**Attachment 9**  
**NRC3-12-0003**  
(17 pages)

**Response to RAI Letter No. 70**  
**(eRAI Tracking No. 6244)**

**RAI Question No. 03.07.01-7**

**Response to RAI Letter No. 70**  
**(eRAI Tracking No. 6244)**

Figure 3.7.1-259 Comparison of Fermi 3 RB/FB and CB SSI FIRS with the NUREG/CR-0098 (Reference 3.7.1-210) median rock spectral shape and enveloping NUREG/CR-6728 (Reference 2.5.2-255) CEUS spectral shape, both scaled to a minimum PGA of 0.1g. All spectra are for 5 % damping.

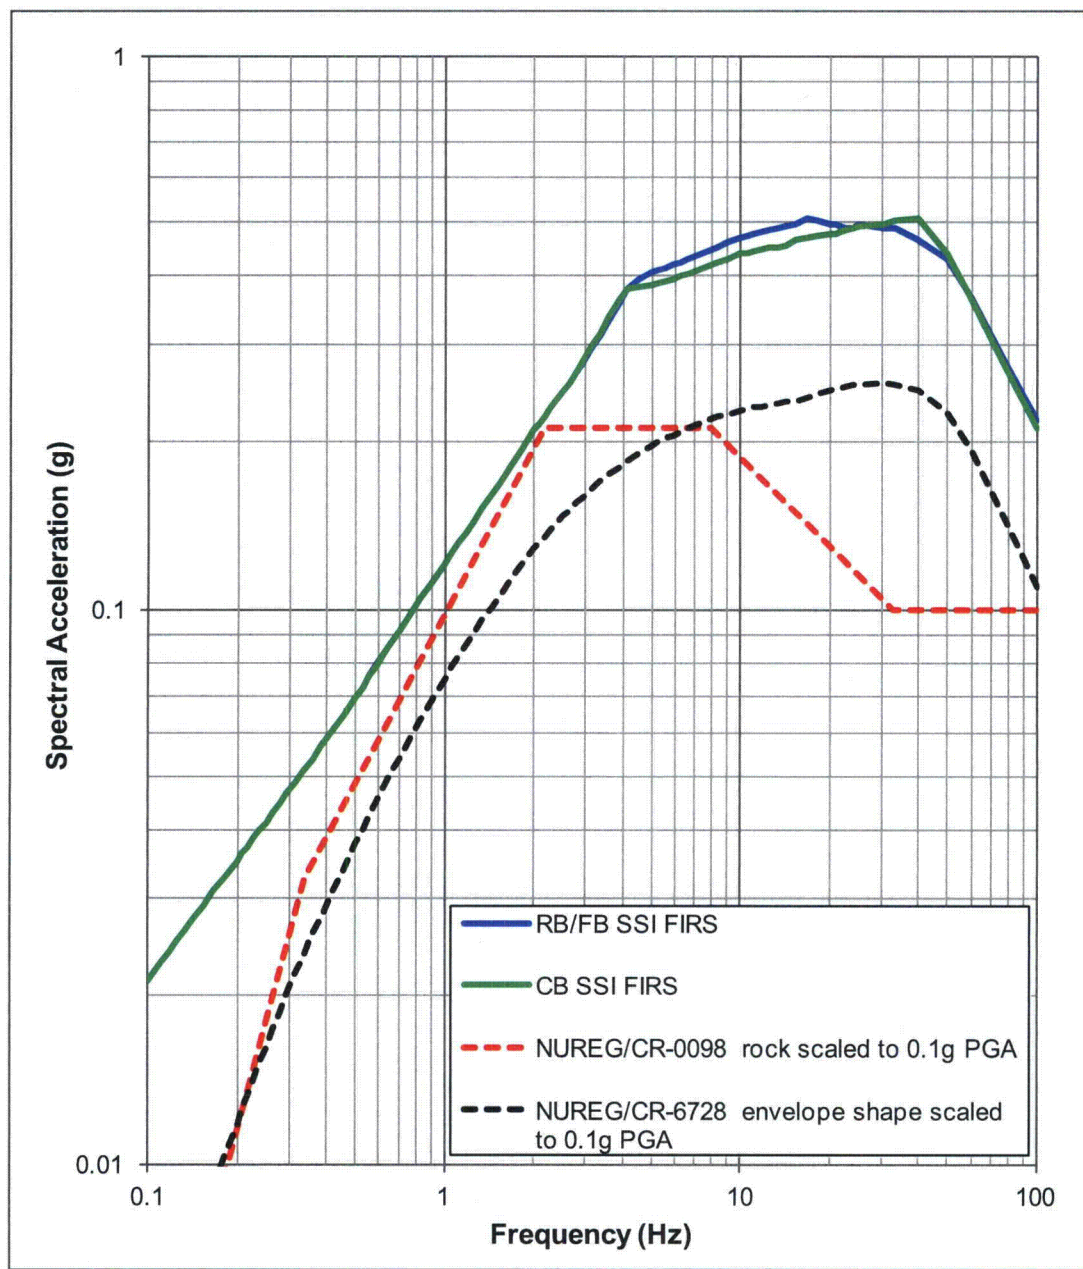
*However, the guidance in SRP 3.7.1 and ISG-017 also indicates that, to satisfy the regulatory requirements, the minimum horizontal PGA of 0.1g should correspond to a smooth broad-band spectral shape such as the one described in RG 1.60. Therefore, the applicant is requested to provide in the FSAR comparison plots of the RB/FB and CB horizontal FIRS with the RG 1.60 horizontal spectrum anchored at 0.1 g, which demonstrate that the RB/FB and CB horizontal FIRS envelope the RG 1.60 spectrum at all frequencies of interest. The staff needs this information to confirm that the site-specific seismic input used in the site-specific SSI analysis meets 10 CFR Part 50, Appendix S.*

FSAR Subsection 3.7.1.1.4.6, FSAR Subsection 3.7.1.4, and new FSAR Figure 3.7.1-259 are revised as shown on the markup included in the response to RAI 03.07.01-6.

Figure 1: Spectral ratios for 2% damping over 5% damping and 10% damping over 5% damping developed from the NUREG/CR-6728 CEUS rock site time history database.

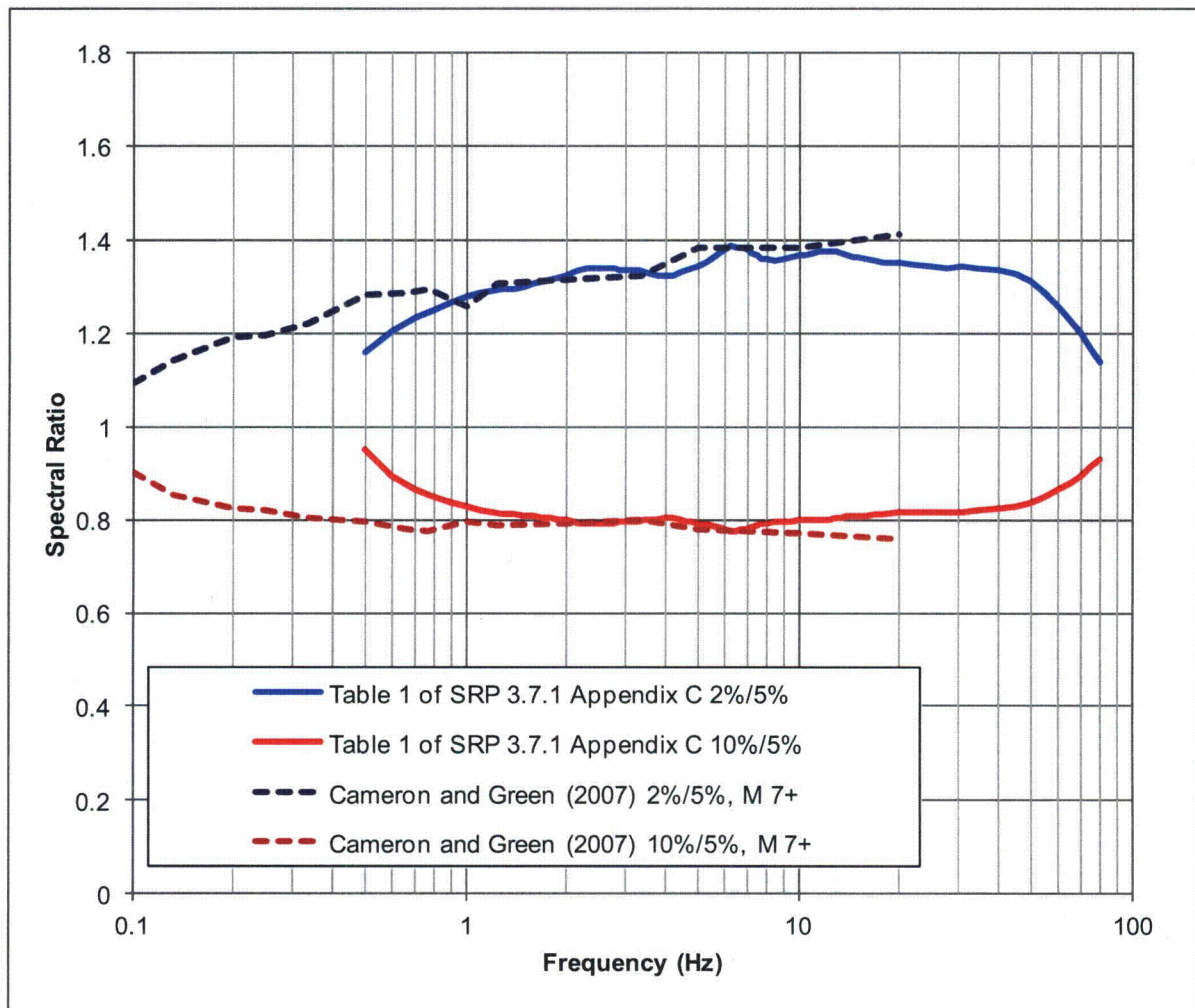
*SRP Acceptance Criteria 3.7.1.II.1B also specifies that PGV/PGA should be consistent with the characteristic values for the controlling earthquake. As such, the applicant is requested to provide further justification of the acceptability of the PGV/PGA values for the artificial time histories being higher than the selected controlling earthquake. The applicant is also requested to provide comparison of the response spectra of the artificial time histories and the estimated target spectra (SSI FIRS) at 2 percent and 10 percent damping values for RB/FB and CB.*

The values listed in Table 1 of SRP 3.7.1 Appendix C represent averages of the spectral ratios obtained for recordings in all magnitude and distance bins. As shown on Figure 1, the spectral ratios trend towards unity as the spectral frequency decreases below 1 Hz. This reflects the range in magnitudes – including numerous recordings from magnitudes less than 6 – represented in the database. The effect of damping on spectral ordinates at low frequencies is magnitude dependent (e.g., Bommer and Mendis, 2005; Cameron and Green, 2007). Cameron and Green (2007) have performed a similar analysis to that described in SRP 3.7.1 Appendix C with the modification that separate scale factors are computed for the different magnitude bins. The Fermi 3 site hazard at low spectral frequencies is due to large magnitude earthquakes (see FSAR Table 2.5.2-219) and the seed time histories used to develop the SSI input time histories are recordings of the M 7.6 1999 Chi-Chi, Taiwan, earthquake. Also shown on Figure 1 are the spectral ratios developed by Cameron and Green (2007) from M 7+ recordings in the NUREG/CR-6728 CEUS rock site time history database. The Cameron and Green (2007) M 7+ ratios are similar to those from Table 1 of SRP 3.7.1 Appendix C for frequencies above 1 Hz. At frequencies below 1 Hz, the Cameron and Green (2007) M 7+ ratios do not trend towards unity. They show a stronger damping effect than those from Table 1 of SRP 3.7.1 Appendix C. This effect results from the greater energy content at low frequencies in recordings from larger magnitude earthquakes. This effect is reduced in the spectral ratios of Table 1 of SRP 3.7.1 Appendix C by including a range of magnitudes. Both sets of spectral ratios were used to develop estimated SSI FIRS for 2 percent and 10 percent damping in the following comparisons; however, the Cameron and Green (2007) spectral ratios are considered more appropriate because of the earthquake magnitude associated with the SSI FIRS time histories. These estimated FIRS are developed only for the frequency range contained in the two sets of spectral ratios (0.1 to 20 Hz for the Cameron and Green spectral ratios and 0.5 to 80 Hz for the SRP spectral ratios). Based on the fact that there is little to no difference between the spectral ratios for CEUS horizontal and vertical motions presented in Appendix C of SRP 3.7.1,
